RE: **Westside Medical Office** (Revised for Building Phasing)
4410 Irving Blvd. NW
Grade & Drain Plan for Grading Permit

B13-D022A

DRAINAGE AND TRANSPORTATION INFORMATION SHEET

RE: **Westside Medical Office** (Revised for Building Phasing)
4410 Irving Blvd. NW
Grade & Drain Plan for SO-19 & Building Permit

GRADING AND DRAINAGE PLAN

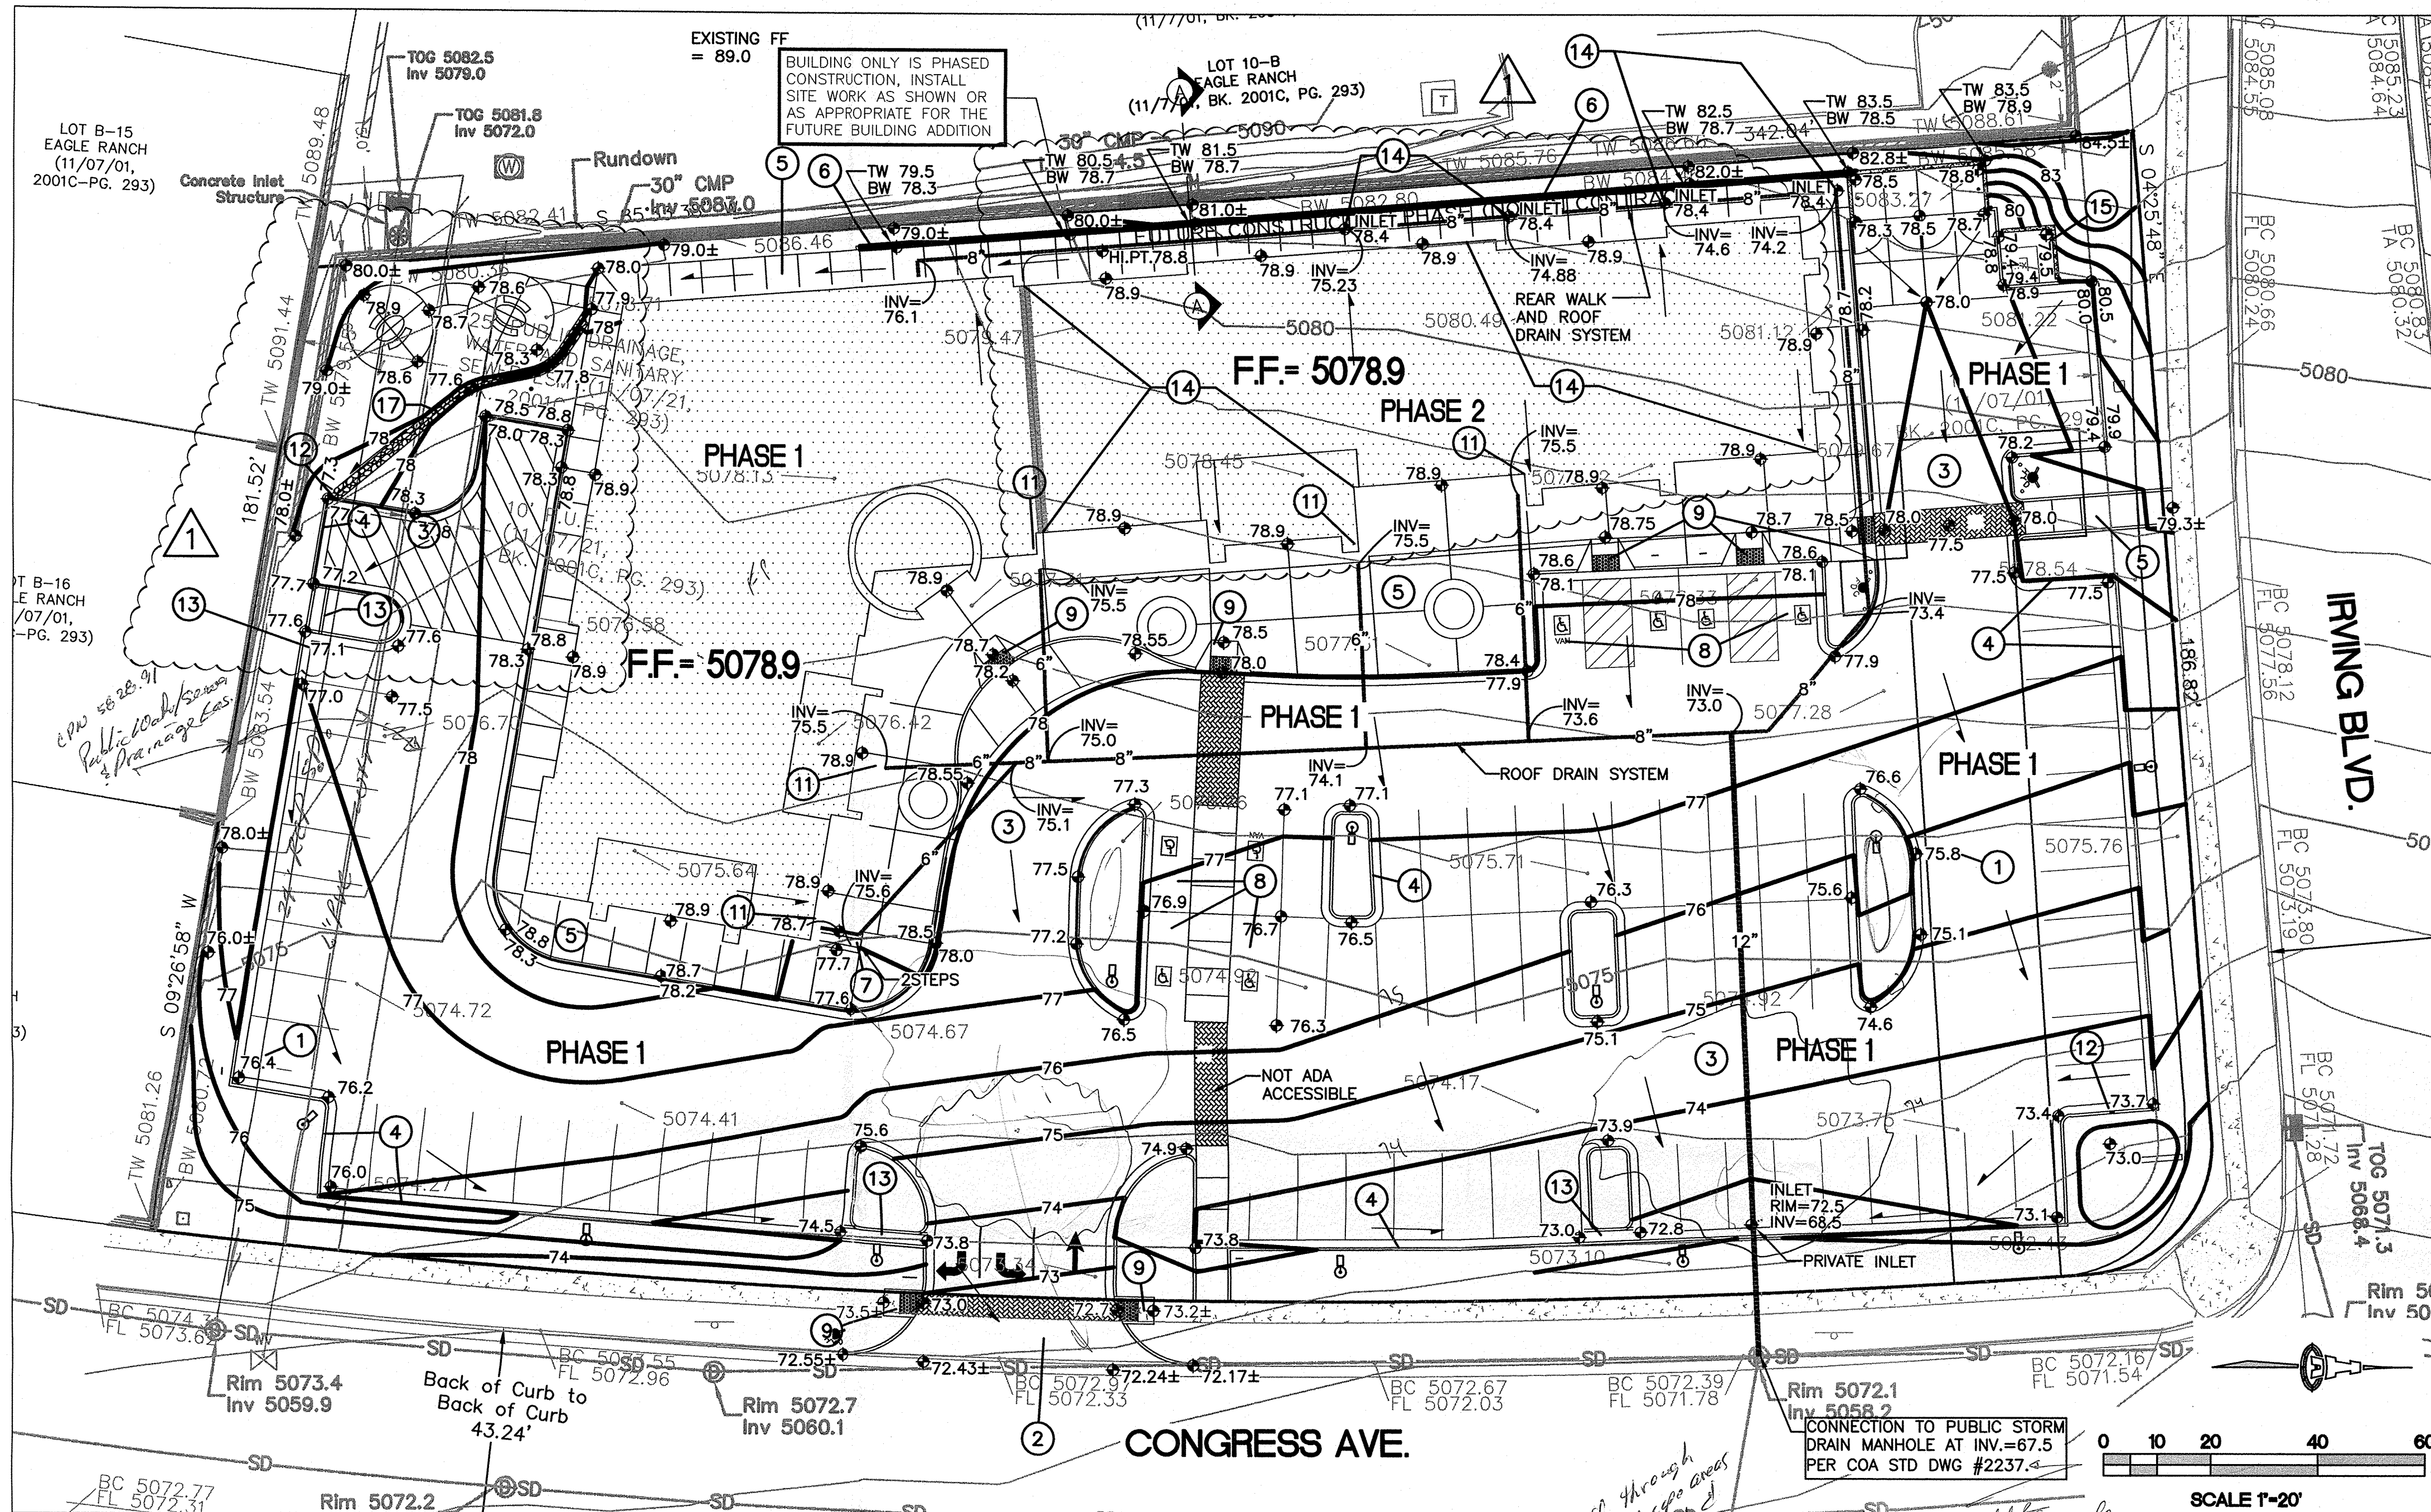
1. Hydrology is requesting that proposed landscape areas be depressed to retain/infiltrate the rain that falls on them, and where possible, route storm runoff through these areas for water quality and water harvesting benefits.
2. The Line type used for the private storm drain system on the plan does not match the Legend for that system.
3. Show the existing 24" RCP Storm Drain (and 6" WL) in the Public Easements along the west edge of the parcel (ref. City Project 5828.91). Provide sufficient, as-built pipe grades to ensure no conflict with the proposed improvements.

1. Hydrology is requesting that proposed landscape areas be depressed to retain/infiltrate the rain that falls on them, and where possible, route storm runoff through these areas for water quality and harvesting.
2. The Line type used for the private storm drain system on the plan does not match the Legend for that system.
3. Show the existing 24" RCP Storm Drain (and 6" WL) in the Public Easements along the west edge of the parcel (ref. CPN 5828.91). Provide sufficient, as-built pipe grades to ensure no conflict with proposed improvements.
4. Update the SO-19 Notes to reference COA Standard Spec update #8, and the NM One Call number of "811."
5. Regarding the new Detail Sheet, CG-501:
 - a. Dimension the thickness on the Rock Swale Detail.
 - b. The ½" Expansion joints seem very close together on the Curb Opening Detail.

2 ROCK SWALE

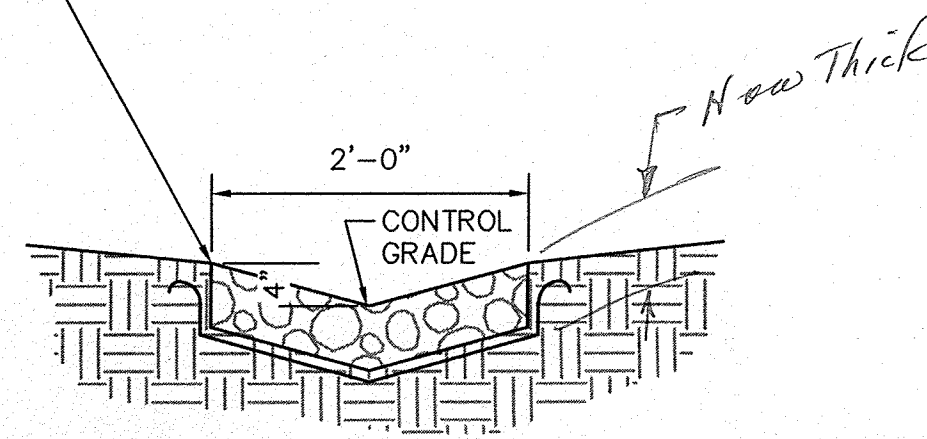
4. Update the "SO-19 Notice to Contractors" to reference COA Standard Spec Update #8, and the NM One Call number of "811."
5. Regarding the new Detail Sheet, CG-501:
 - a. Dimension the thickness on the Rock Swale Detail.
 - b. The ½" Expansion joints seem very close together on the Curb Opening Detail.
